**ADDENDUM NO:** One (1)

**PROJECT:** St John Elementary – Hurricane Laura Repairs  
CPSB Hurricane Laura Damages Restoration Program  
HL-050-01

**ARCHITECT'S PROJECT NO:** MA2124

**DATE:** April 27, 2023

**1 NORTH ELEVATION**  
 SCALE: 1/16" = 1'-0"

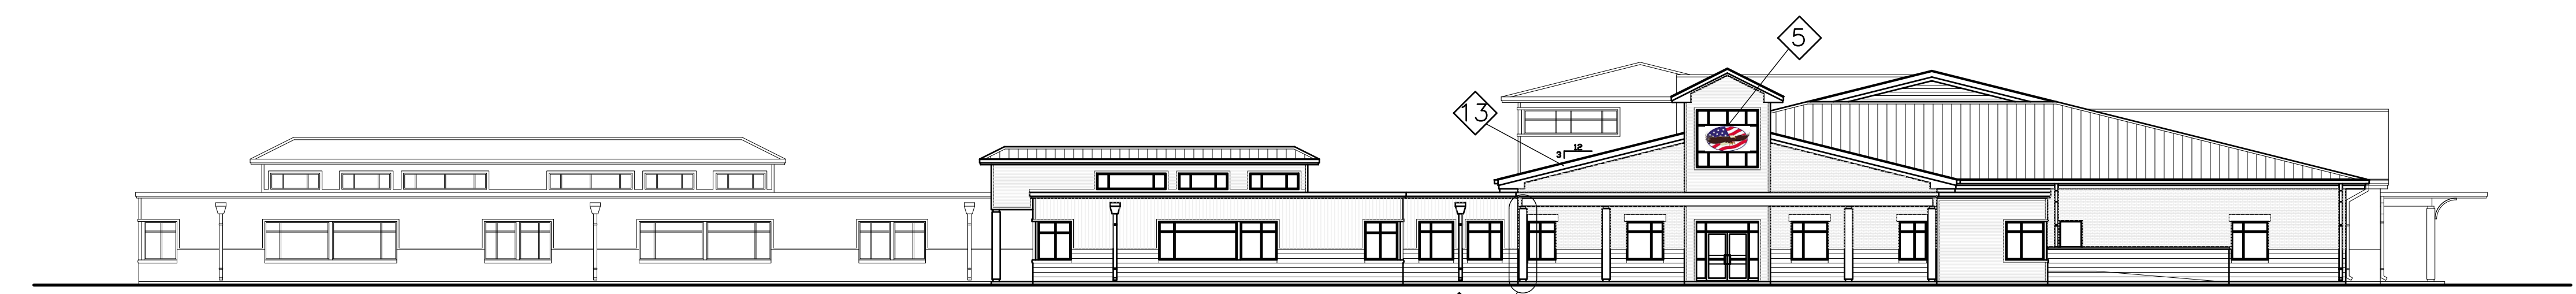
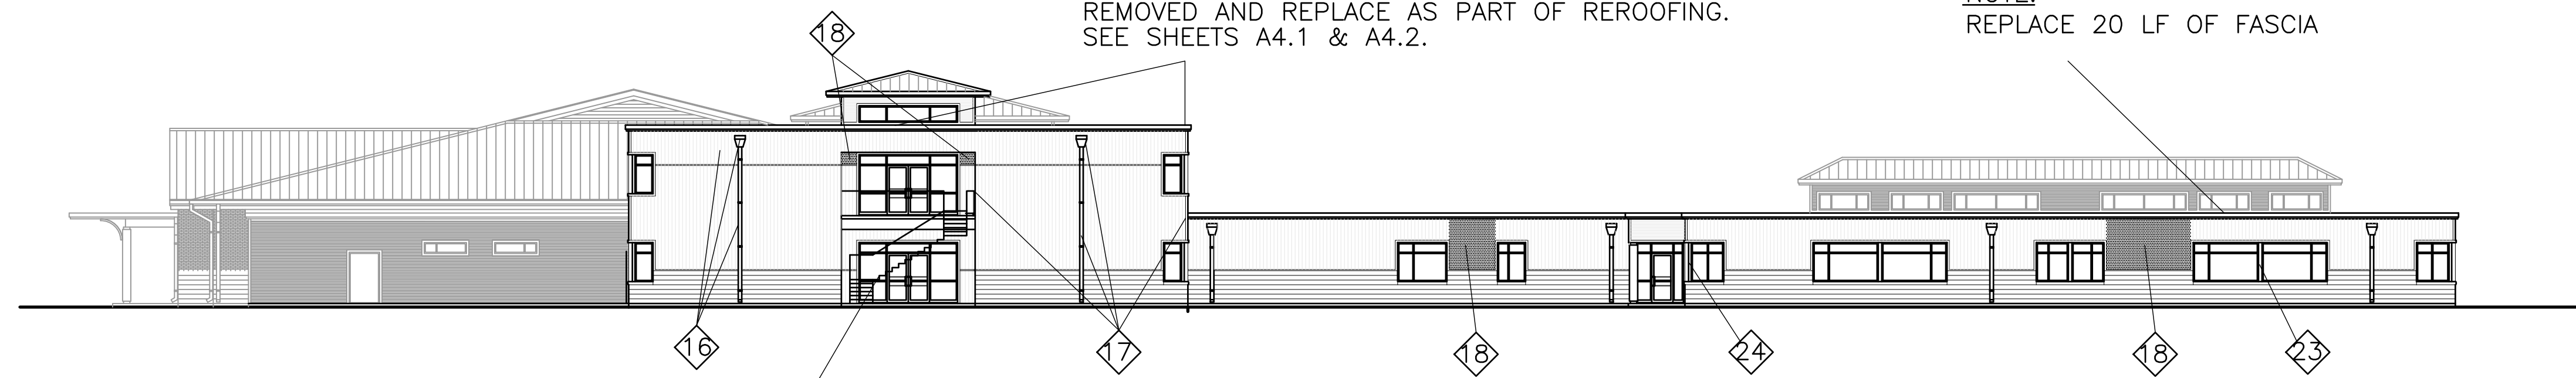
- 23) Include the attached, revised **Sheet A6.1** – Exterior Elevations in the Bid Documents.
- 24) In reference to **Sheet A7.3** – Reference Photos:
- a. Disregard Images 6 and 7.

\*NOTE:  
 DAMAGED METAL WINDOW TRIM TO BE  
 REPLACED (APPROX. 3 LF). MATCH EXISTING.

GENERAL NOTES:  
 - REPLACE ALL LOOSE ROOF SHINGLES LODGED IN  
 METAL WALL PANELS.  
 - \* REPLACE ALL EXISTING AND MISSING FOAM  
 CLOSER PIECES (APPROX. 3400 LF) AROUND  
 WINDOWS AND DOORS AT METAL WALL PANELS.  
 ALL WINDOWS AND DOORS AT EXPOSED FASTENER  
 HORIZONTAL PANELS.

\* INDICATES WHAT IS REVISED

**SCOPE OF WORK - LEGEND**

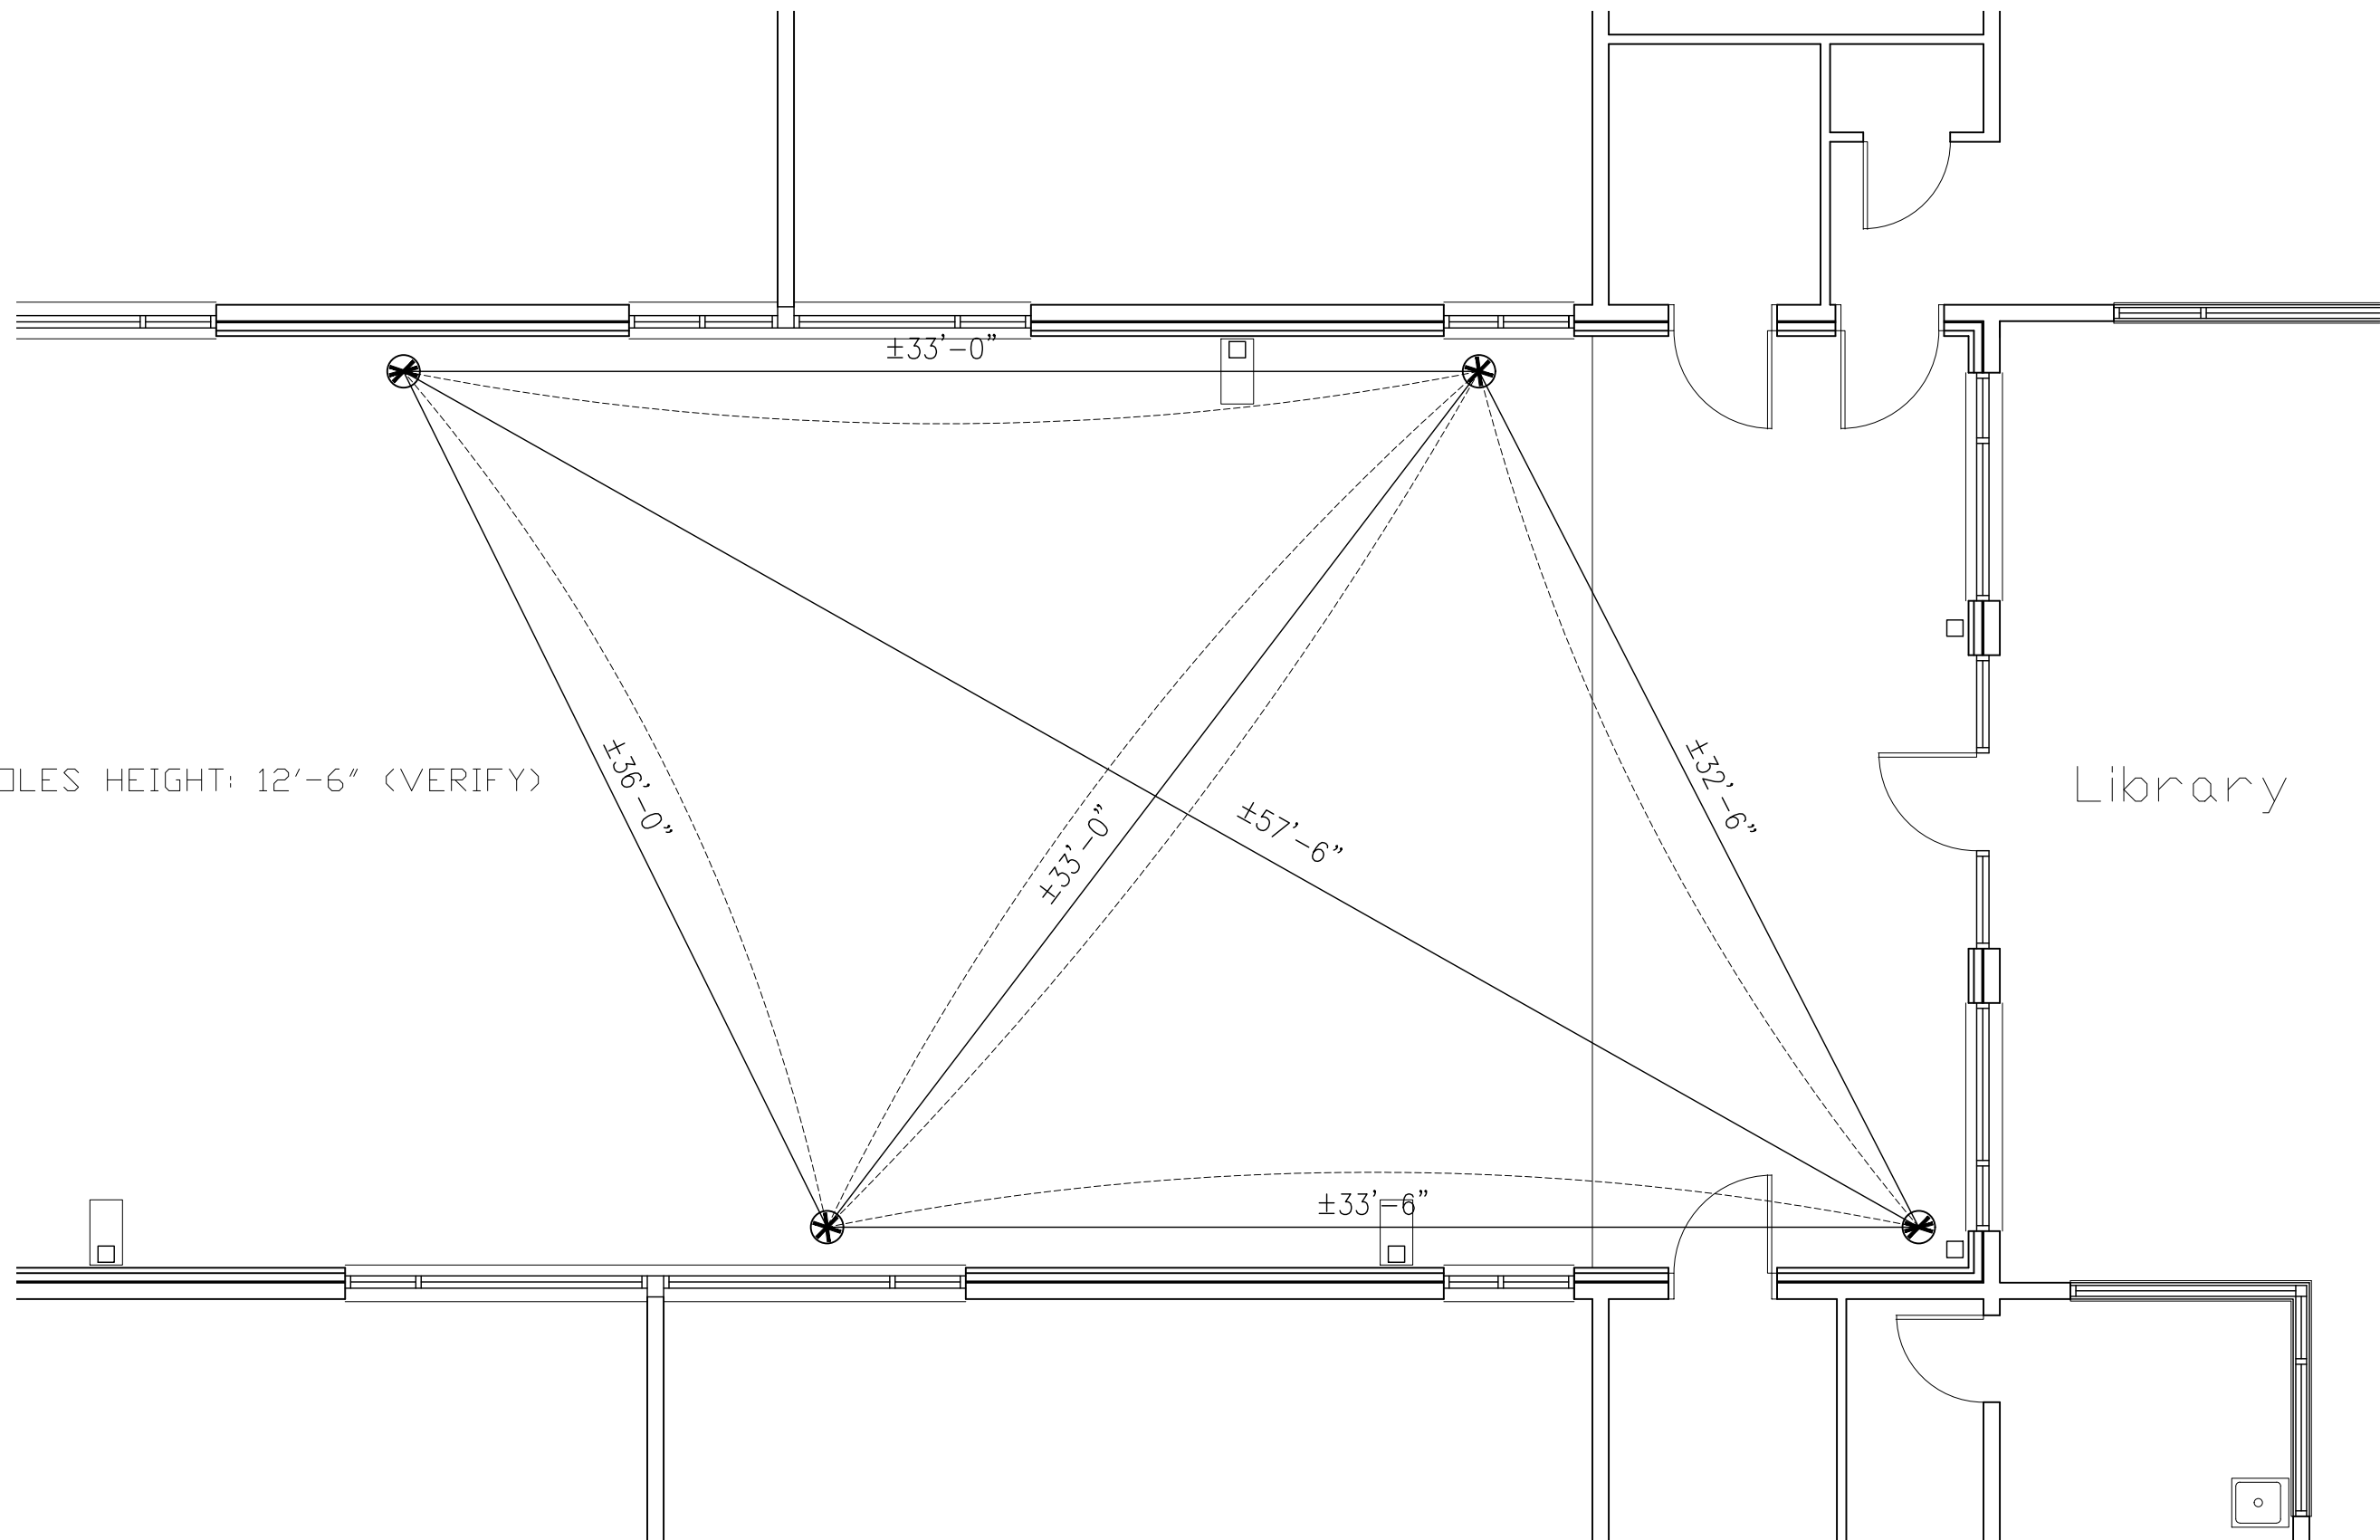
- 17) In reference to **Sheet A2.1** – Overall Floor Plans – Scope of Work, see remarks below:
  - a. Note 16: metal wall panels (approx. 12 SF), leader head (qty 1), and downspout (approx. 23 LF).

- b. Note 17: corner trim (approx. 17 LF), leader head (qty 1), and downspout (approx. 23 LF).
  - c. Note 18: metal wall panels (approx. 650 SF).
  - d. Note 19: leader head (qty 1) and downspout (approx. 23 LF).

- e. Note 20: operable casement window (qty 1) and metal trim (approx. 12 LF).
  - f. Note 21: 7' x 5'6" window and frame (qty 1).
  - g. Note 22: metal wall panels (approx. 38 SF).

- h. Note 23: storefront cap trim (approx. 6 LF).
  - i. Note 24: corner storefront cap trim (approx. 6 LF).
  - j. Note 25: leader head (qty 1) and downspout (approx. 23 LF).

- k. Note 26: operable casement window (qty 1) and storefront cap trim (approx. 6 LF).
  - l. Note 27: leader head (qty 1) and downspout (approx. 23 LF).

- m. Note 28: storefront cap trim (approx. 6 LF).
  - n. Note 29: metal trim (approx. 10 LF) and siding (approx. 24 LF).
  - o. Note 48: closure trim (approx. 12 LF).

WORK LOCATION LEGEND	DESCRIPTION OF WORK
5	REMOVE AND REPLACE DAMAGED SIGNAGE WITH NEW TO MATCH EXISTING. ASI OR APPROVED EQUAL. (SEE PHOTO 1/A7.1)
3	REPLACE MISSING 24 GA. PREFINISHED METAL FASCIA TRIM AND CONTINUOUS CLEAT TO MATCH EXISTING. (SEE PHOTO 2/7.1)
*16	RESECURE METAL WALL PANEL (APPROX 12 SF), LEADER HEAD, AND DOWNSPOUT (APPROX. 23 LF) TO WALL. SEE 1/A7.2
*17	REPLACE DAMAGED AND MISSING CORNER TRIMS (APPROX. 17 LF), LEADER HEAD, AND DOWNSPOUT (APPROX. 23 LF) WITH NEW 24 GA PREFINISHED METAL CORNER TRIMS, LEADER HEAD, AND DOWNSPOUT TO MATCH EXISTING COLOR AND PROFILE. SEE 2/A7.2.
*18	REPLACE DAMAGED AND MISSING WALL PANELS (APPROX. 660 SF) OVER STEEL HAT CHANNELS AT THIS AREA. COLOR AND PROFILE TO MATCH EXISTING. SEE 3/A7.2.
*19	REPLACE DAMAGED LEADER HEAD AND DOWNSPOUT (APPROX. 23 LF) WITH NEW 24 GA PREFINISHED LEADER HEAD AND DOWNSPOUT. MATCH EXISTING COLOR AND PROFILE. SEE 4/A7.2

*20	REPLACE DAMAGED OPERABLE CASEMENT WINDOW, FRAME AND PREFINISHED METAL WALL TRIM (APPROX. 6 LF). MATCH EXISTING GLASS AND TRIM COLORS AND PROFILE. SEE 5/A7.2
*21	REPLACE DAMAGED WINDOW (APPROX 7' X 5'6") AND FRAME. MATCH EXISTING GLASS AND FRAME COLORS. SEE 6/A7.2.
*22	REPLACE DAMAGED AND MISSING WALL PANELS (APPROX. 38 SF) OVER STEEL HAT CHANNELS AT THIS AREA. COLOR AND PROFILE TO MATCH EXISTING. SEE 7/A7.2.
*23	REPLACE MISSING STOREFRONT CAP TRIM (APPROX. 6 LF) AND RECAULK TO WINDOW FRAME. MATCH EXISTING COLOR AND PROFILE. SEE 8/A7.2.
*24	REPLACE DAMAGED STOREFRONT CORNER CAP TRIM (APPROX. 6 LF) AND RECAULK TO WINDOW FRAME. MATCH EXISTING AND PROFILE. SEE 9/A7.2.
*30	REATTACH AND PUT COLUMN COVER BACK IN PLACE. SEE 3/A7.1. PAINT STRUCTURAL CANOPY MEMBERS. SEE 6/A7.1

*44	REPLACE ALL BROKEN GLASS (APPROX. 70 SF) IN EXISTING FRAME TO MATCH EXISTING. SEE 4/A7.4
45	SECURE EXISTING METAL WALL PANEL TO SUBSTRATE. SEE 5/A7.4
46	PRESSURE WASH WALL EXISTING EXTERIOR WALL & WINDOW SURFACES. ALL MASONRY TO BE CLEANED & SEALED. (TYPICAL)

TENSILE SHADE EXISTING STRUCTURES  
 SCALE: 3/16" = 1'-0"

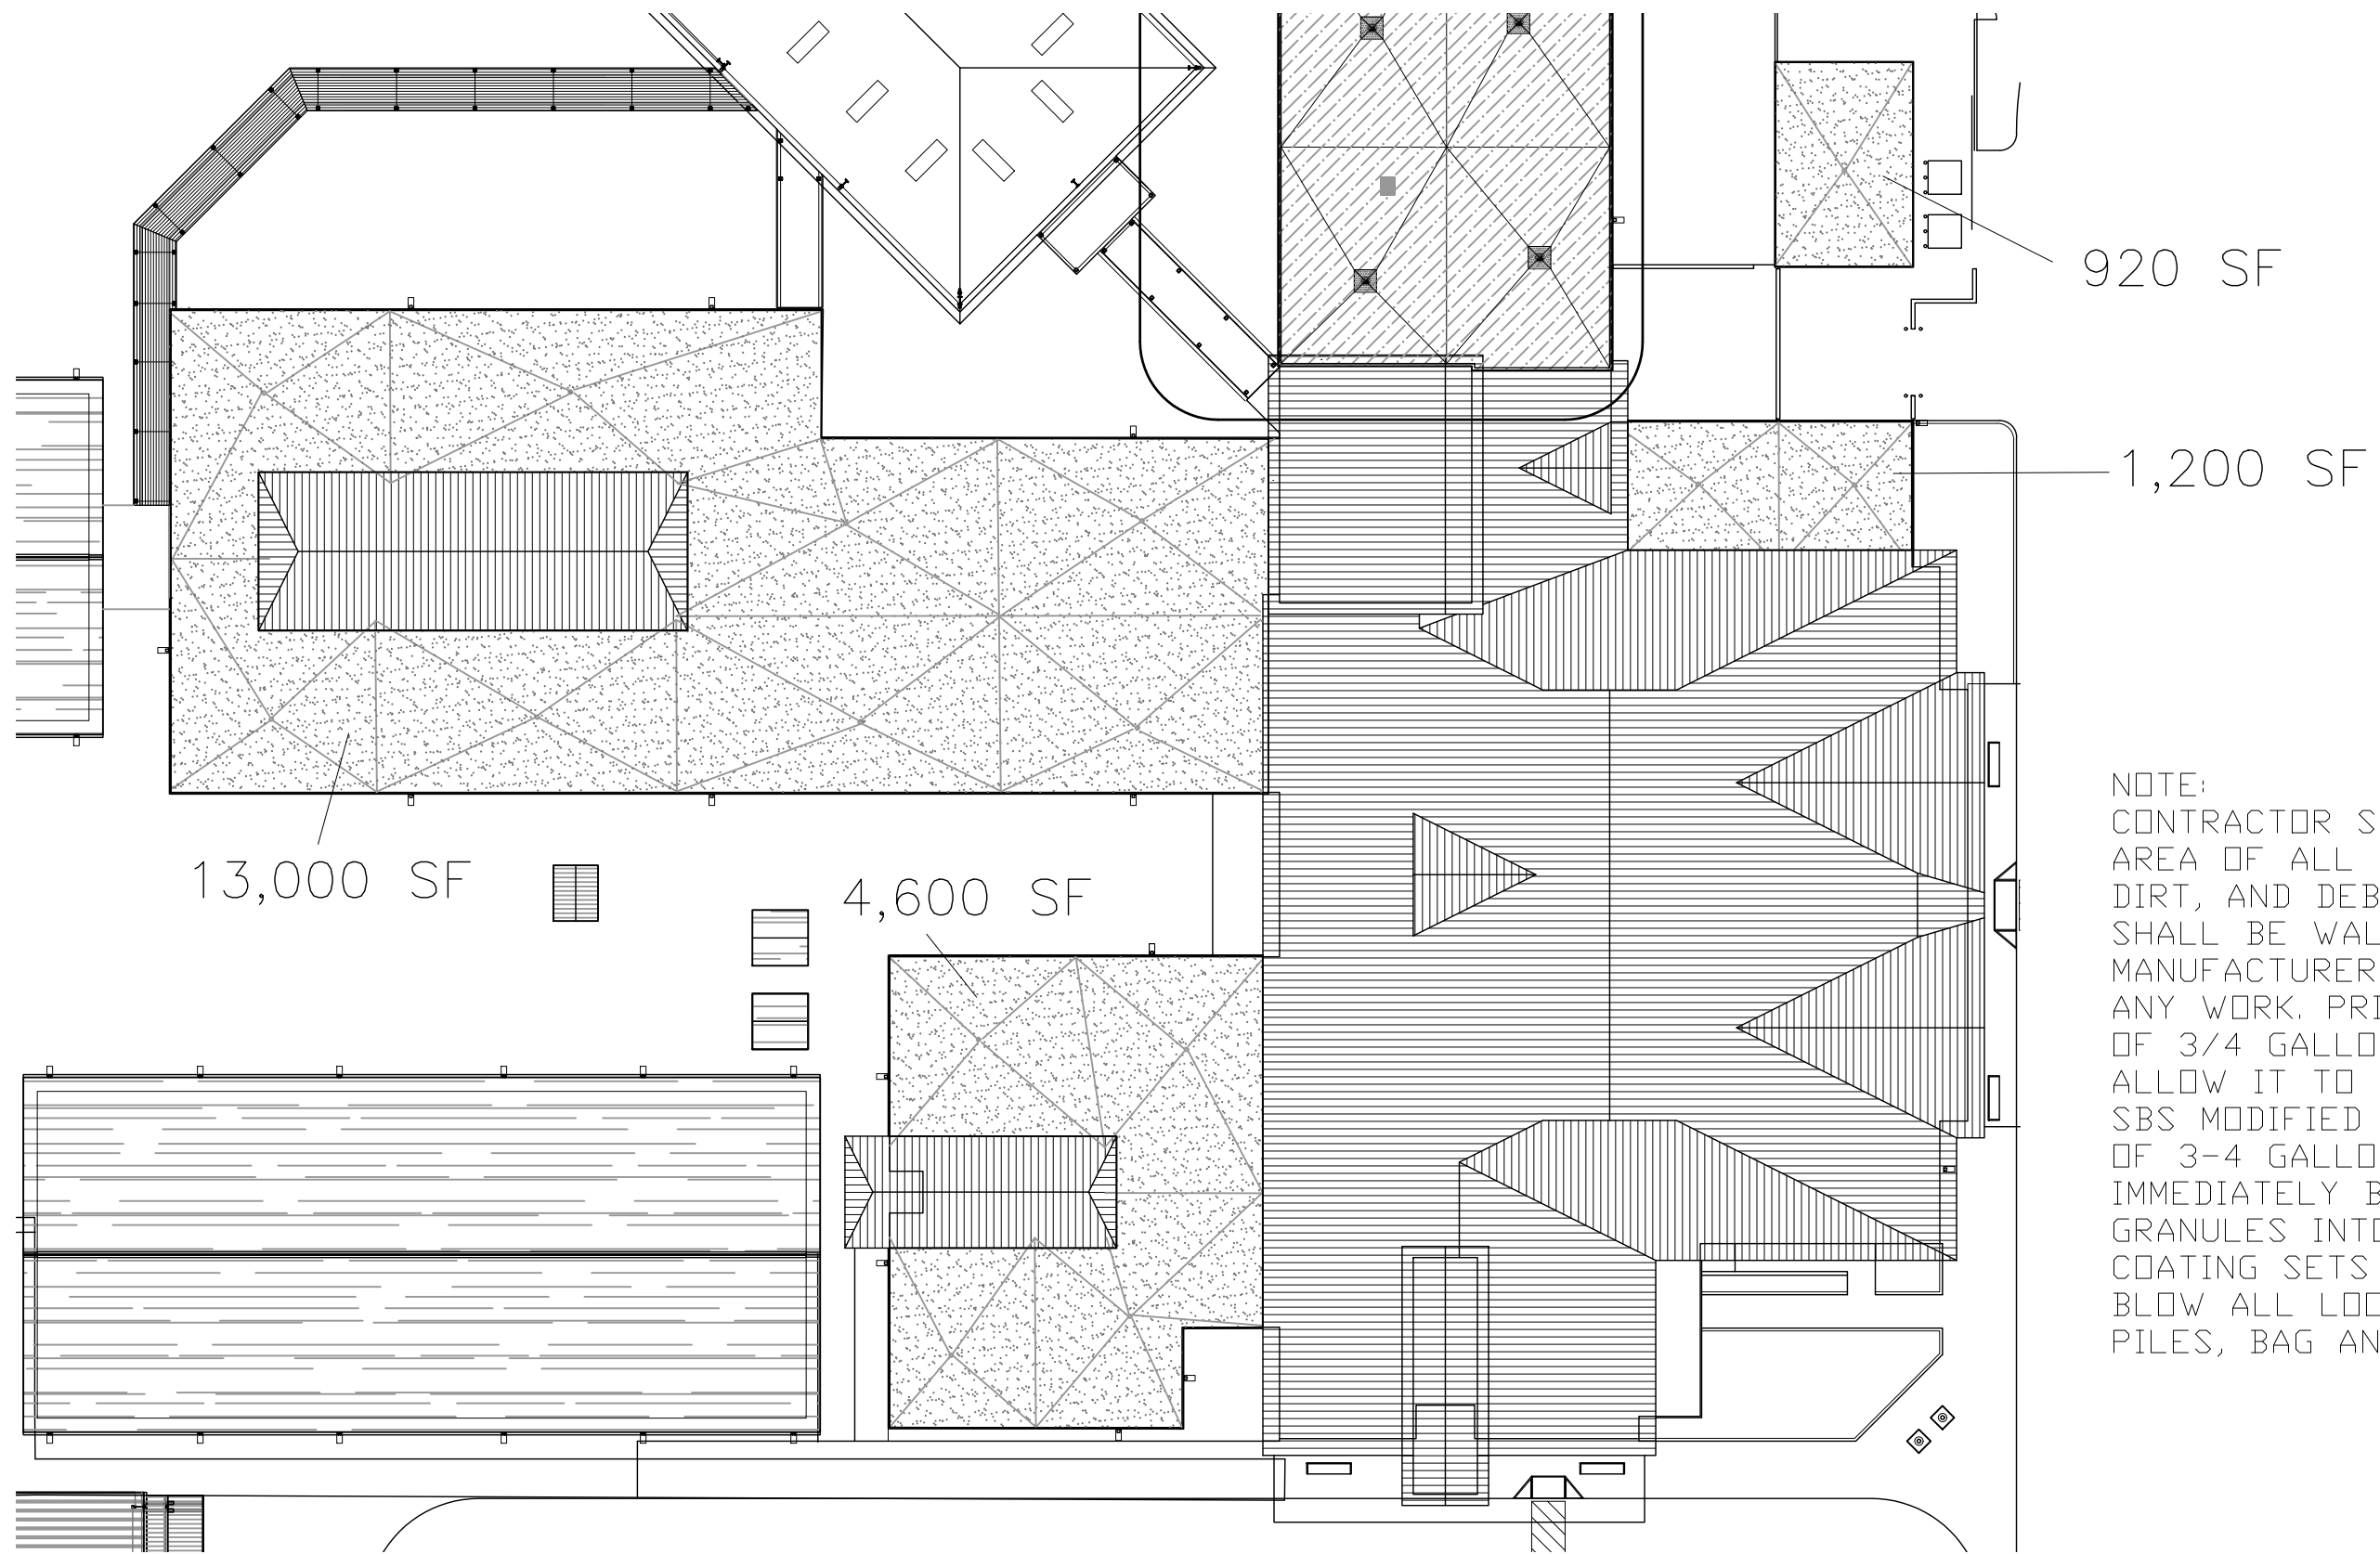
- a. Note 12: 3 panes of glass are being replaced.
  - b. Note 47: Provide tensile shade sails and fasteners. Mount to existing tensile shade structure supports. Manufacturers: Shade Systems and Modern Shade.

- 25) Include attached drawing for **Tensile Structure** dimensions in the Bid Documents.
- 26) Include attached drawing, **Roof Plans** in the Bid Documents.
